PROPOSED ALTERATIONS 40 MONASH PARADE, DEE WHY FOR CARYN CAVANAGH		LOT 53A DP101690
--	--	------------------

SITE PLAN & CALCULATIONS		DRG. NO. 08-16-MON
DATE AUGUST 2016	DRAWN J. WRIGHT	SCALE 1:200
		SHEET NO. 5B

PROPOSED ALTERATIONS 40 MONASH PARADE, DEE WHY FOR CARYN CAVANAGH LOT 53A DP101690			
WEST, EAST & NORTH ELEVATION			DRG. NO. 08-16-MON
DATE AUGUST 2016	DRAWN J. WRIGHT	SCALE 1:100	SHEET NO. 3B

SOUTH ELEVATION & SECTION

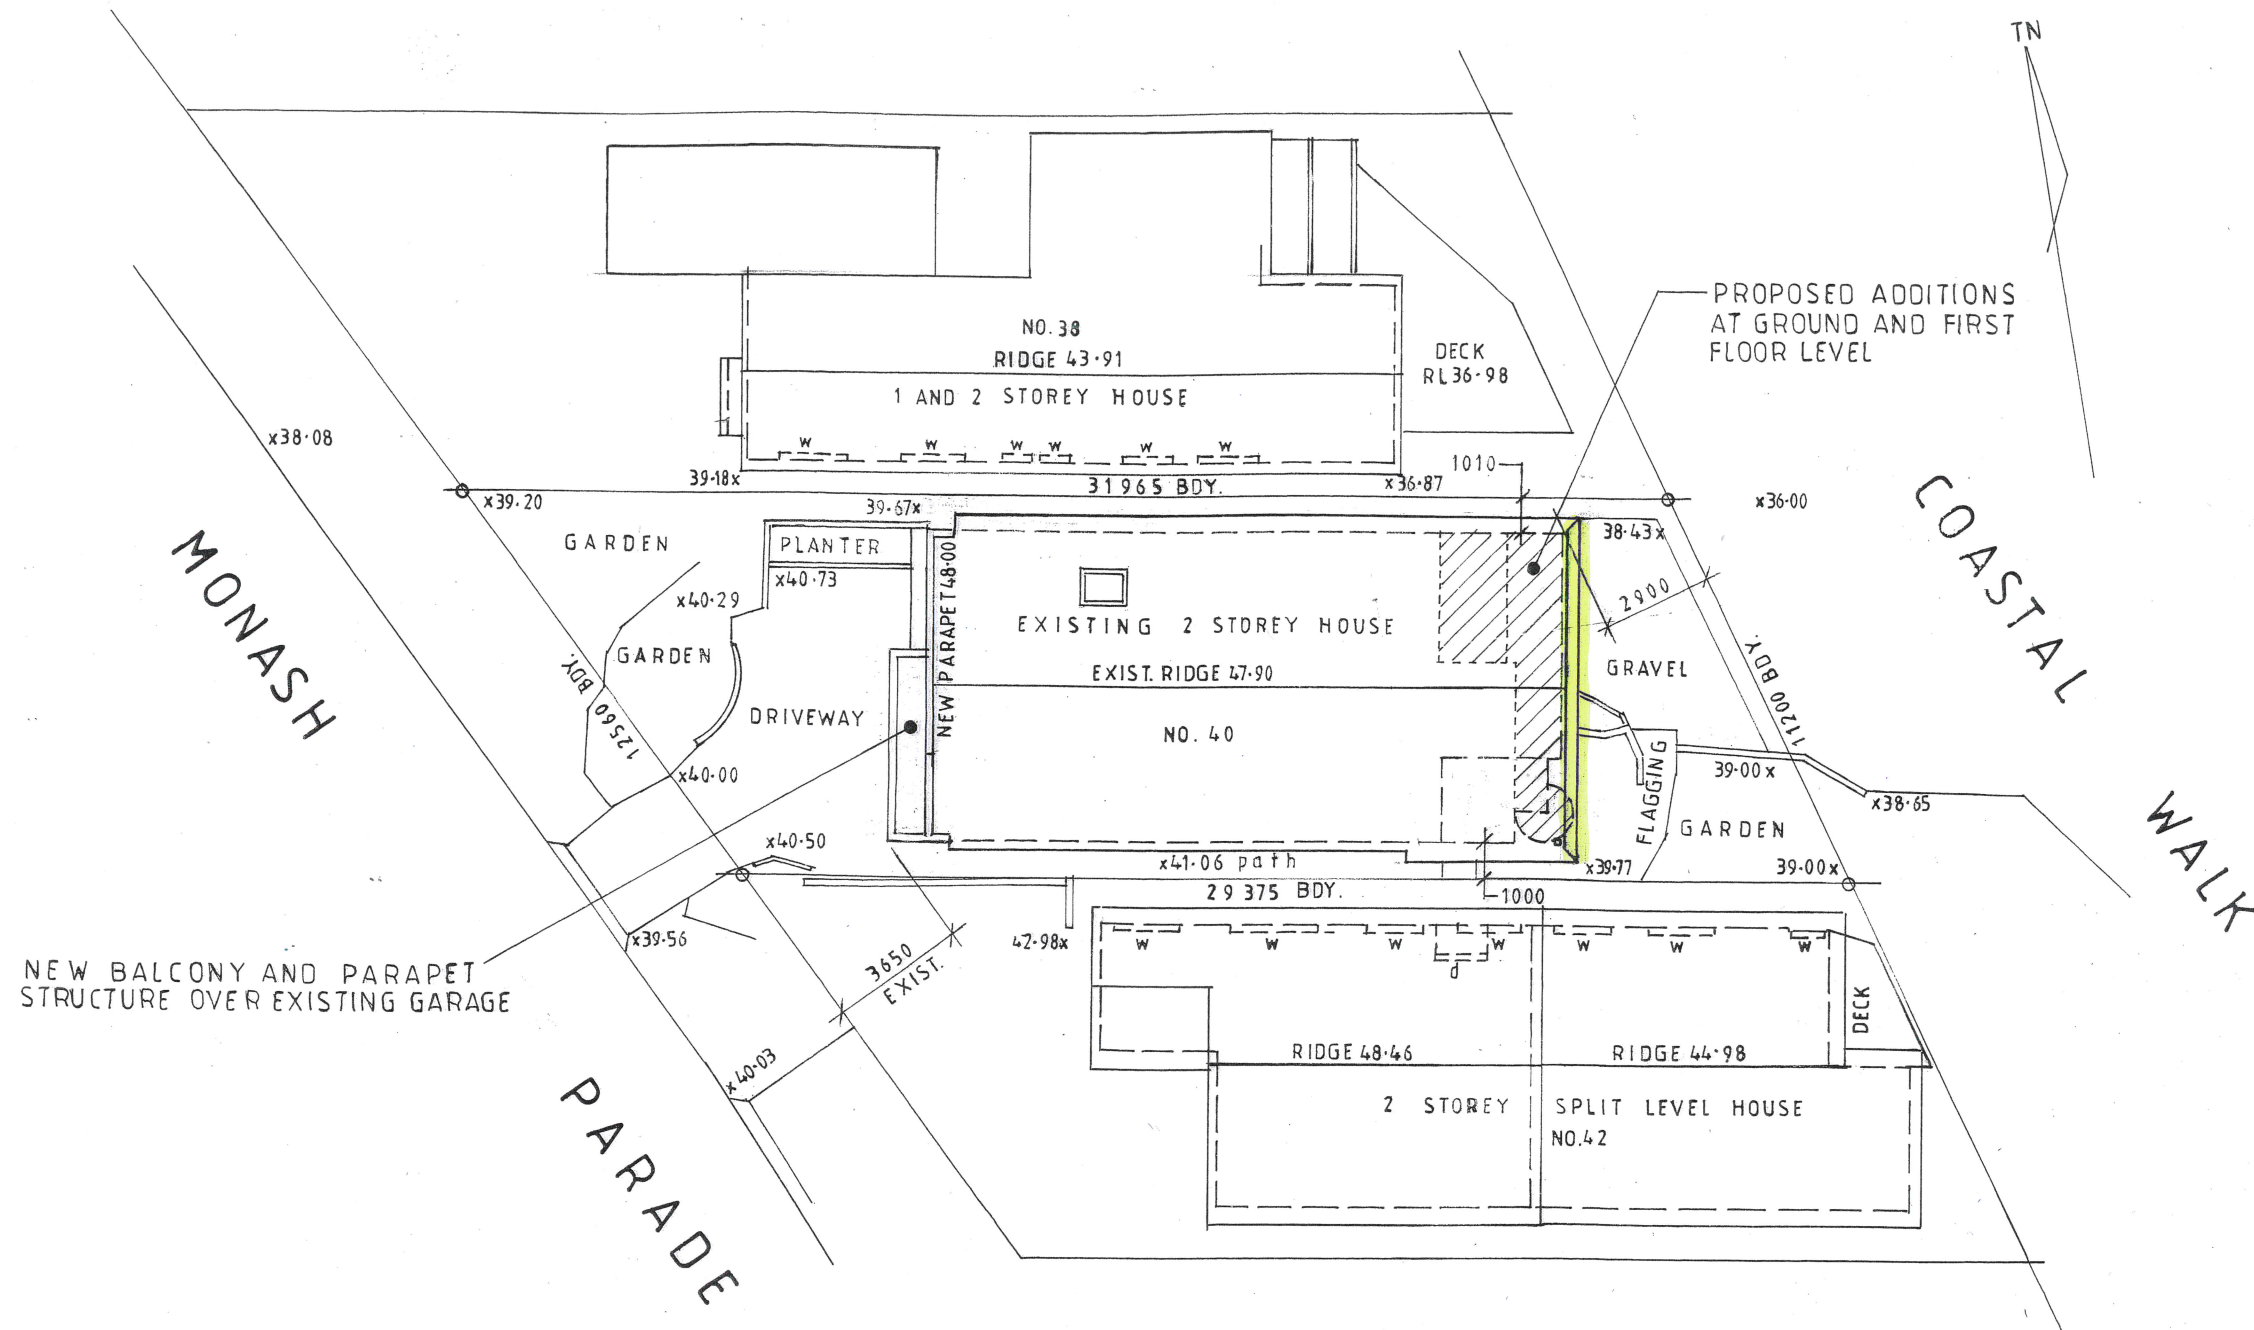
DATE	REVISION
A	12-11-18	SKYLIGHT ADDED
B	25-11-19	EASTERN EAVE WIDTH REDUCED

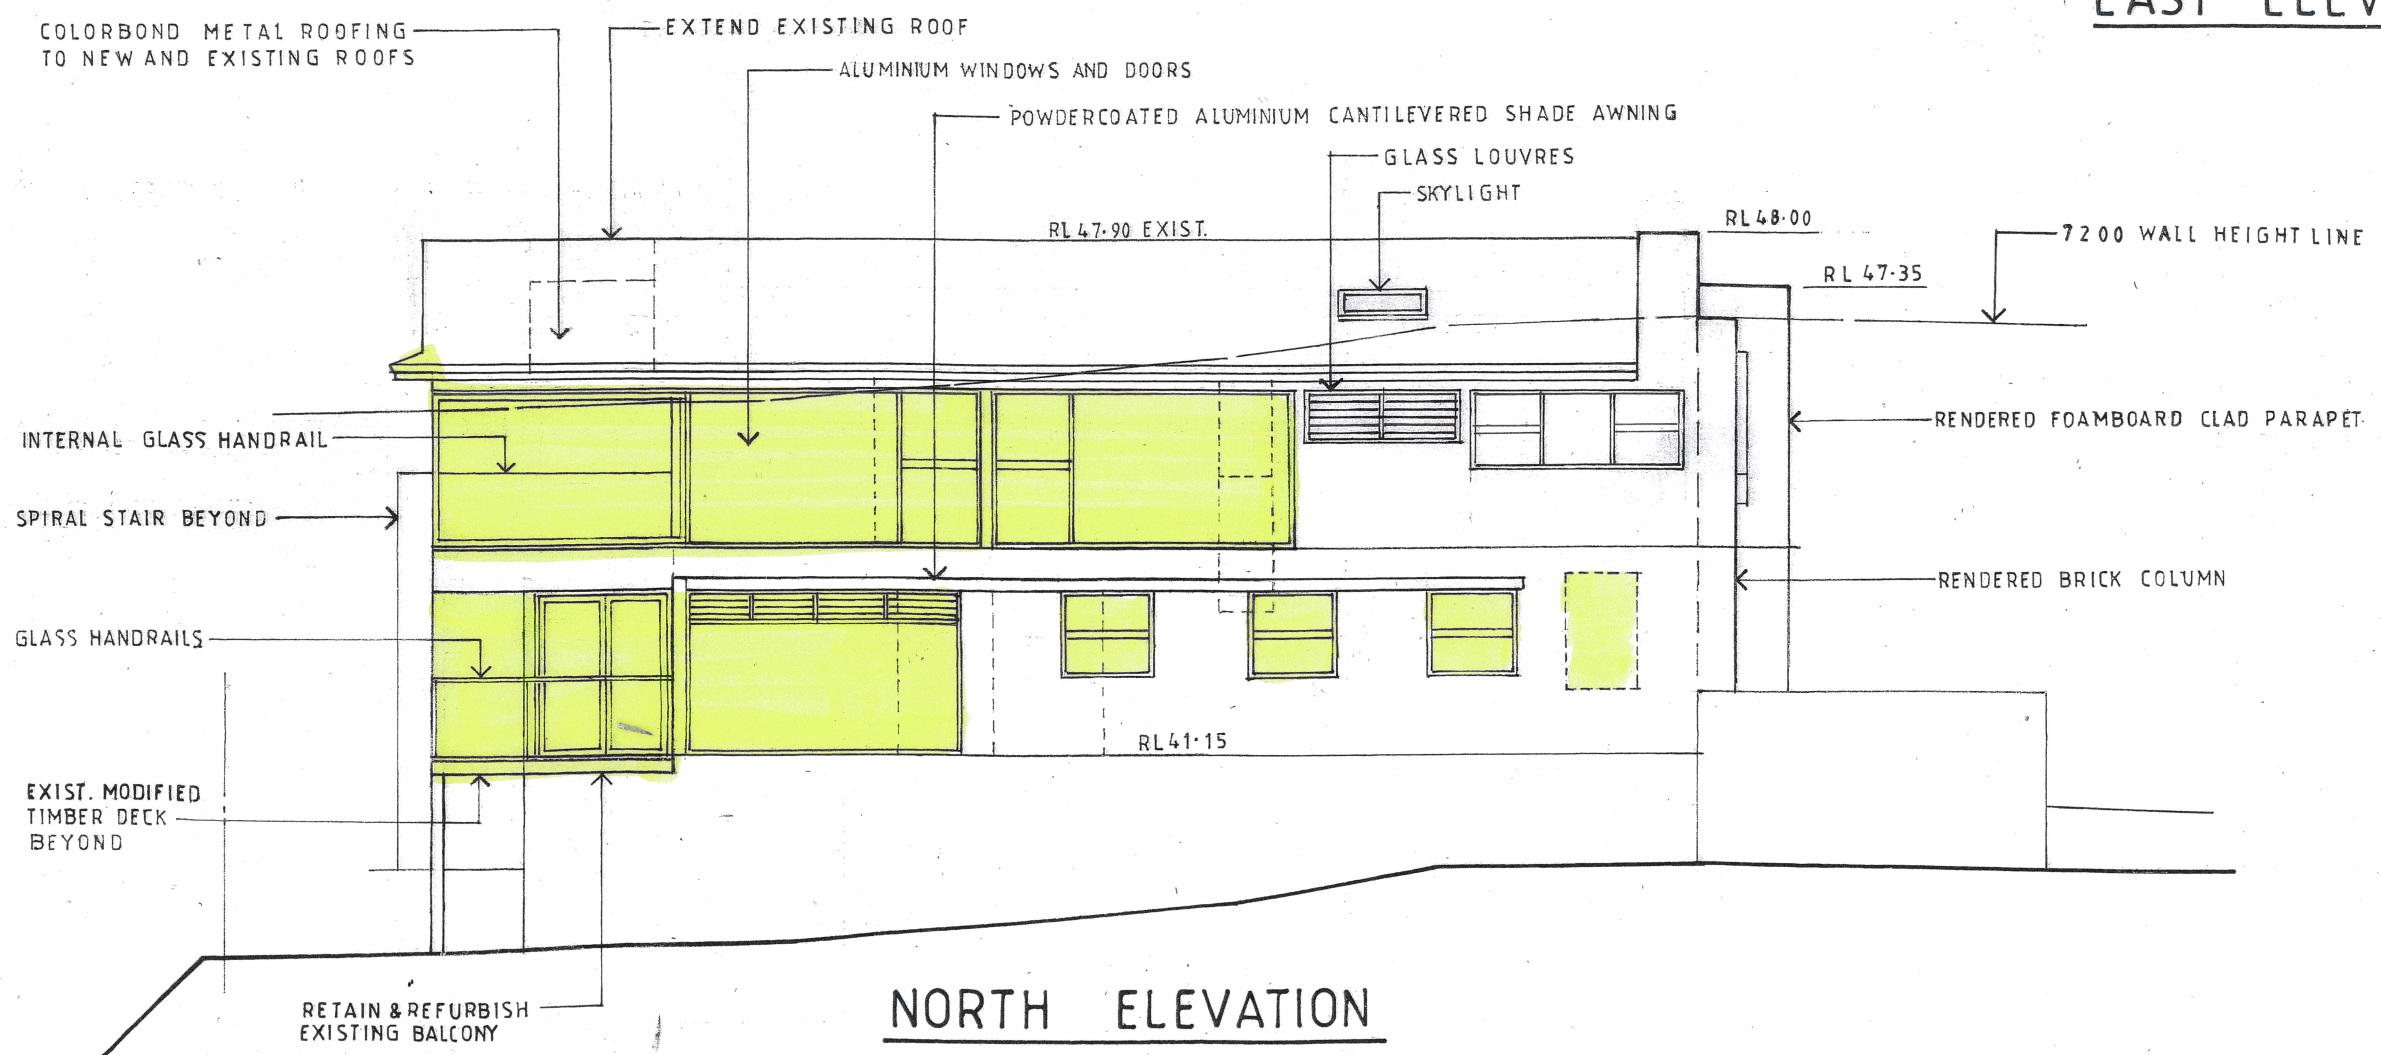
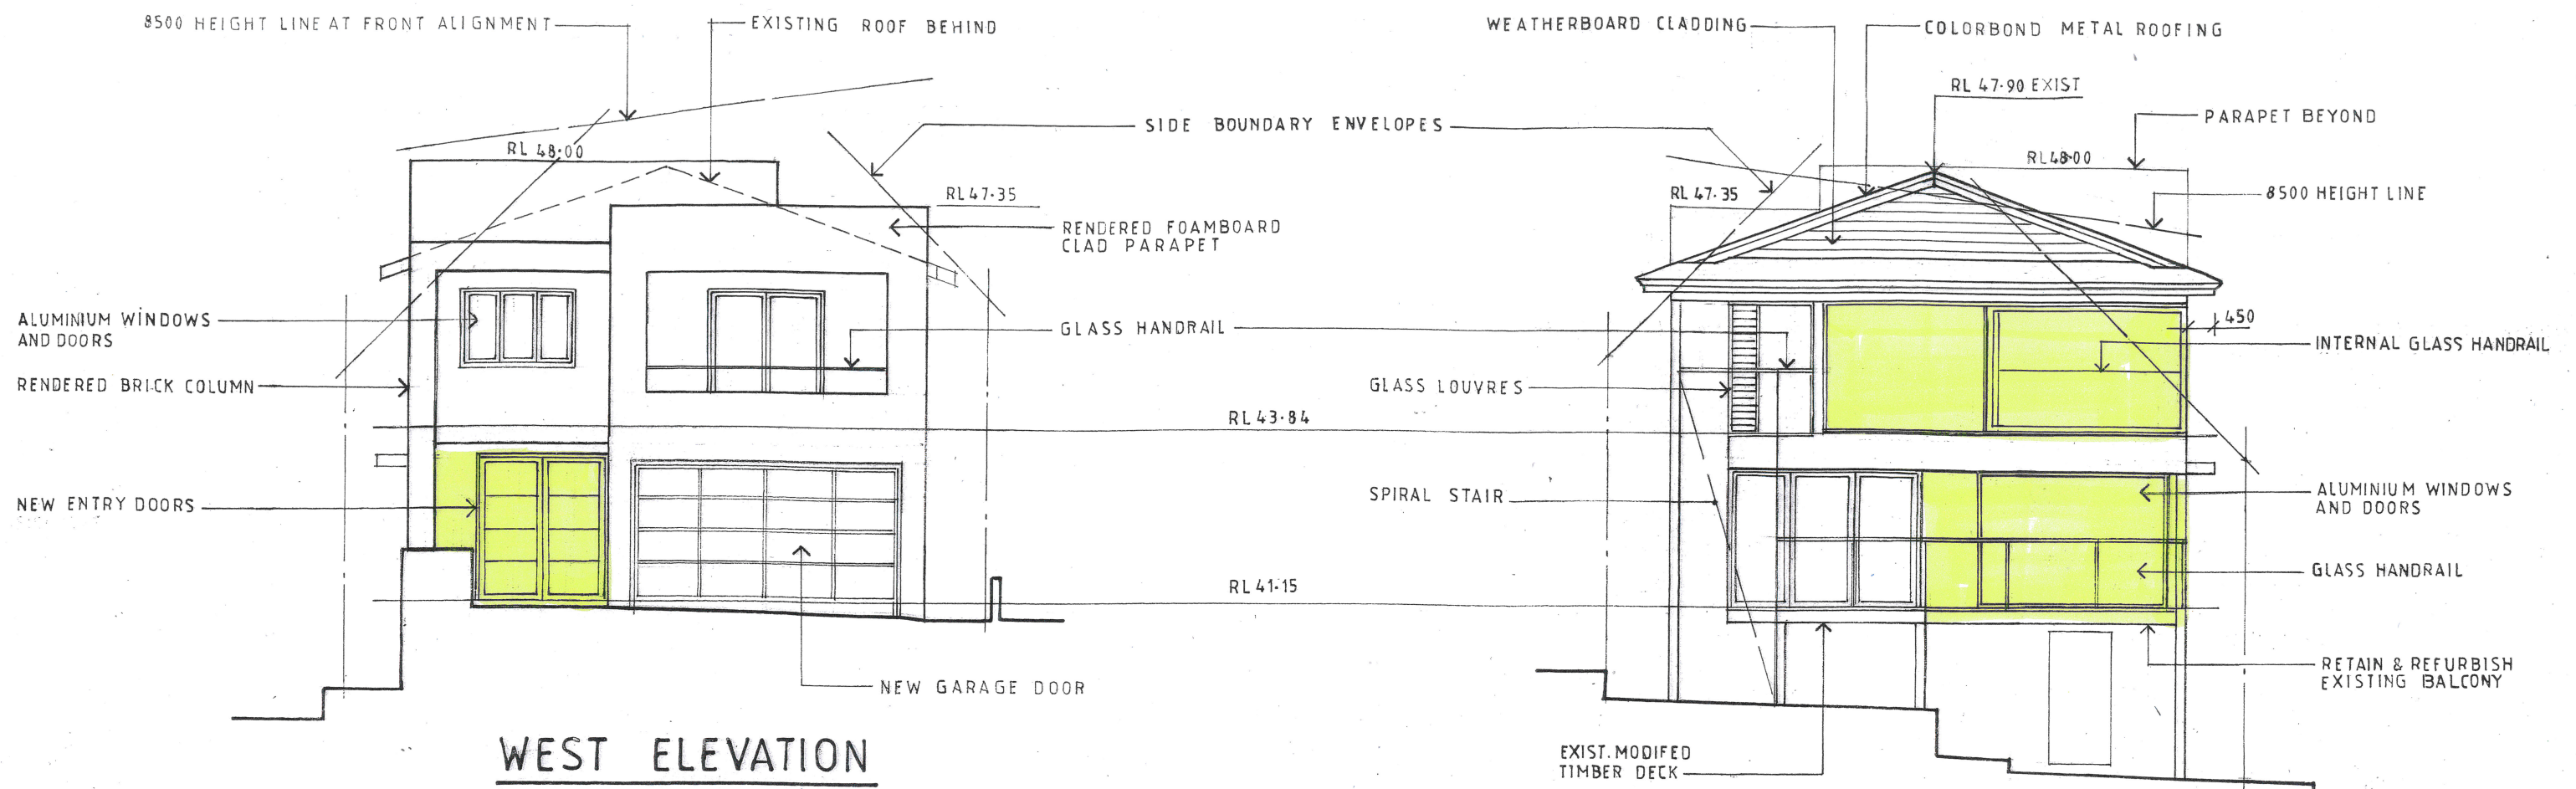
DATE	REVISION
A 12-11-18	WINDOWS TO NORTH ELEVATION REVISED AND SKYLIGHT ADDED.
B 25-11-19	REVISED TO SUIT CHANGES NOTED ON SHEET 1 EASTERN EAVE WIDTH REDUCED
